SUNDRY NOTICES AND REPORTS ON WELLS
Do not use this form for proposals to drill or to re-enter an abandoned well. Use form 3160-3 (APD) for such proposals.

8. Well Name and No.
CONTINENTAL APJ FEDERAL 3

9. API Well No.
30-025-36049

Continental APJ Federal #3
30-025-36049
Yates Petroleum Corporation
Conditions of Approval

WELL NAME: Continental APJ Federal #3 FIELD: Diamond Tail

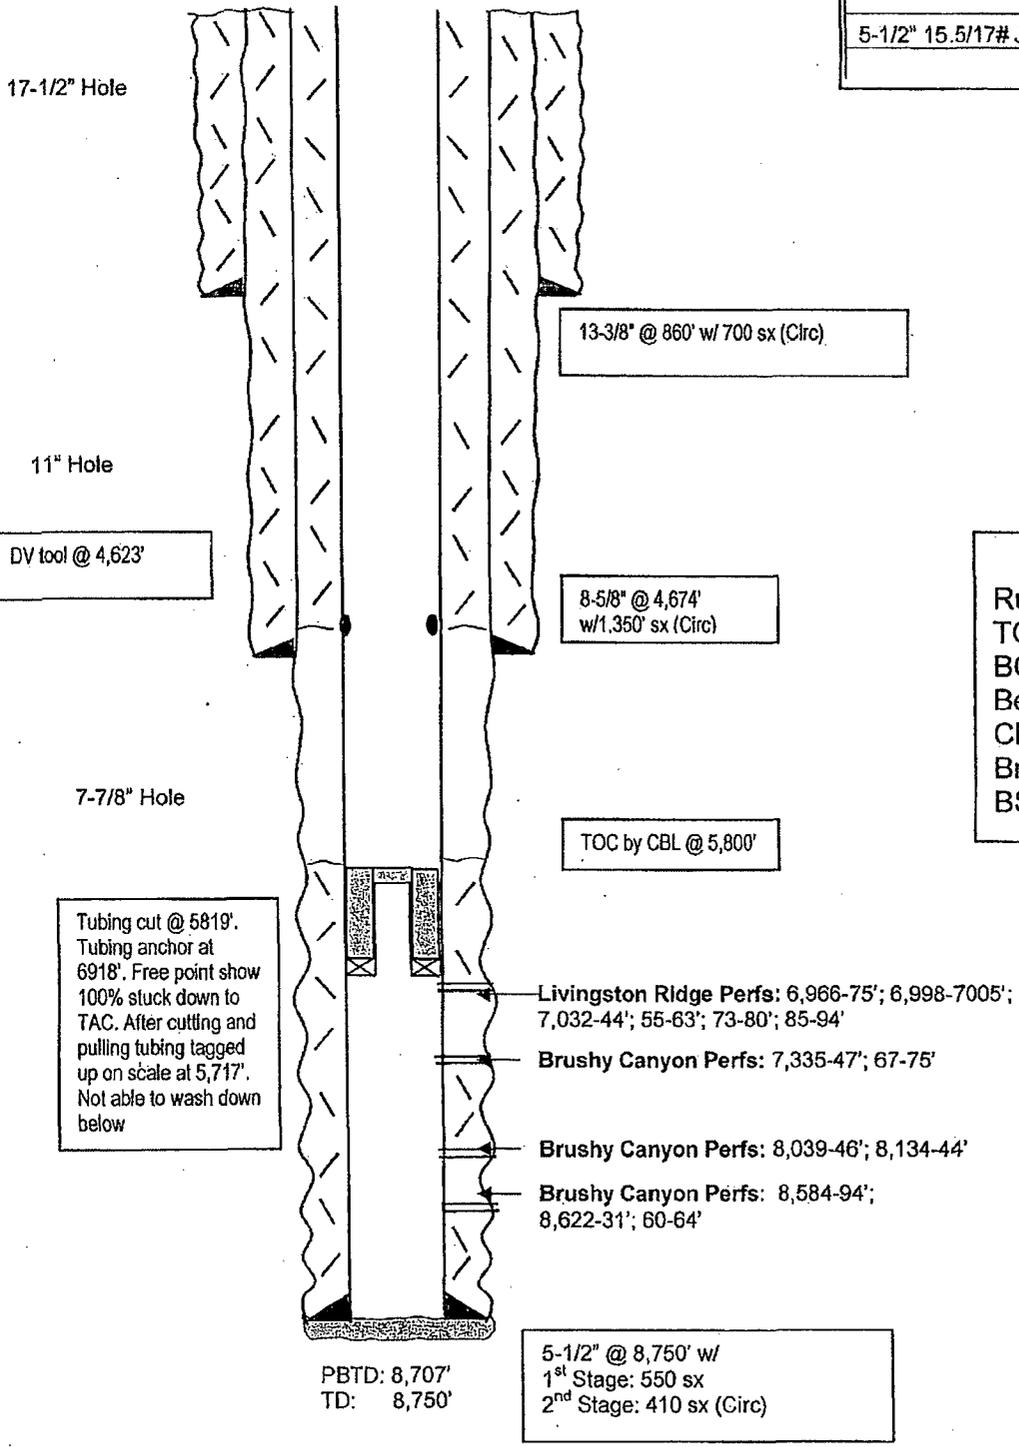
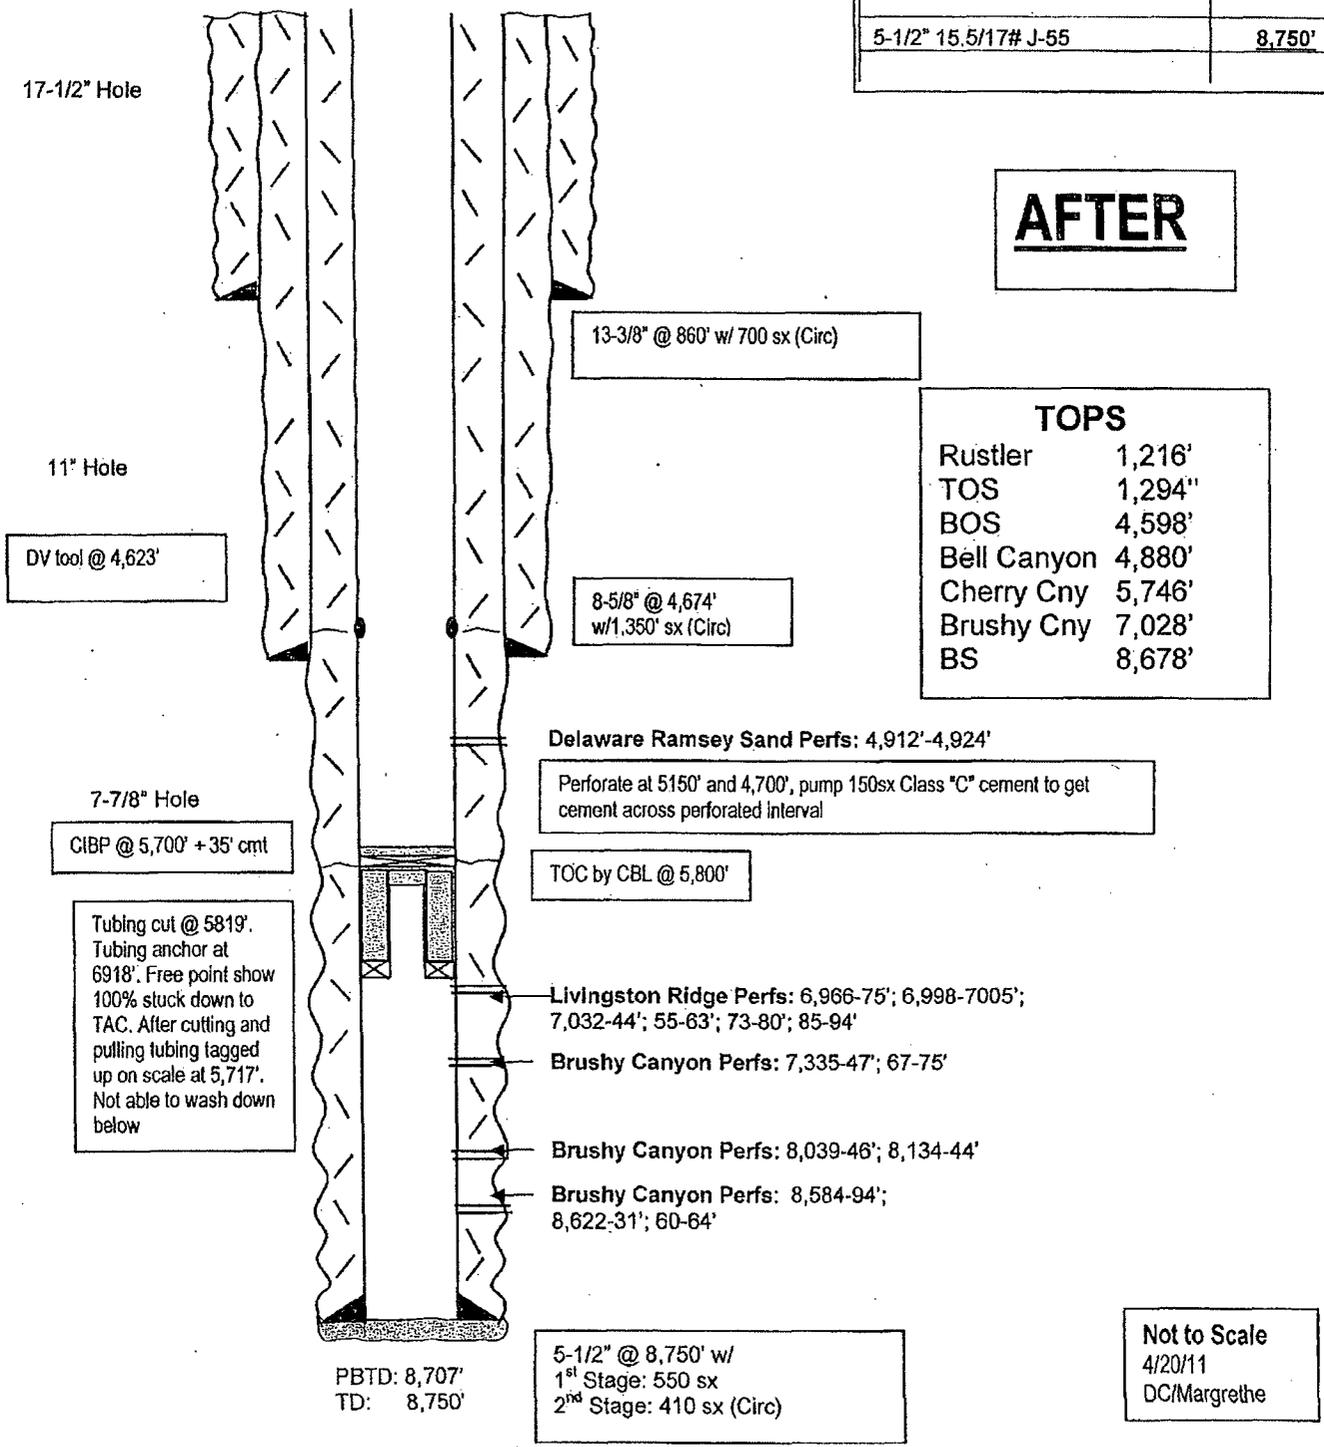
Yates Petroleum Corporation plans to plugback and add Delaware perms as follows:

1. NU BOP. Rig up all safety equipment as necessary.
2. Set a CIBP at 5,700 ft and cap with 35 ft of cement.
3. Perforate 4 squeeze holes at both +/- 4,700 ft and 5,150 ft. Set a retainer at 5,100 ft and pump +/- 150 sacks Class C cement. Pull up above the top perf. SI and WOC.
4. Tag cement. If we don't tag anything down to 5,000 ft, POOH. If we tag before that, POOH and TIH with bit to drill out cement. Need about 75 ft to 100 ft rat hole below bottom perf (which will be 4,924 ft) for the pump.
5. Run a CBL log with 1500 psi on it, to confirm we have cement across the perforation interval and about +/- 200 ft above and below.
6. Perforate Delaware 4,912 ft - 4,924 ft (13 holes).

1. Operator is approved to set a CIBP at 5,700'. Onshore Order #2 states the bridge plug shall be capped with 50' of cement. If a bailer is used to cap this plug, 35' feet of cement shall be sufficient. Tag required.
2. **Provide BLM with an electronic copy (Adobe Acrobat Document) of the Cement Bond Log (CBL) record that will be run as proposed in Step #5 of the submitted Sundry. This electronic copy must be submitted before perforating the Delaware (Step #6). The address that may be use is <pswartz@blm.gov>. For additional questions on this request, the CFO BLM on call engineer may be reached at 575-706-2779.**

3. Must conduct a casing integrity test before perforating the Delaware at 4912 – 4924' (Step #6 of the submitted Sundry). Test should be run for 30 minutes. Submit results to BLM. The CIT is to be performed on the production casing to 500 psi. Notify BLM if test fails. Document the pressure test on a one hour full rotation calibrated recorder chart registering within 25 to 85 per cent of its full range. Greater than 10% pressure leakoff will be viewed as a failed MIT. Less than 10% pressure leakoff will be evaluated site specifically and may restrict injection approval.
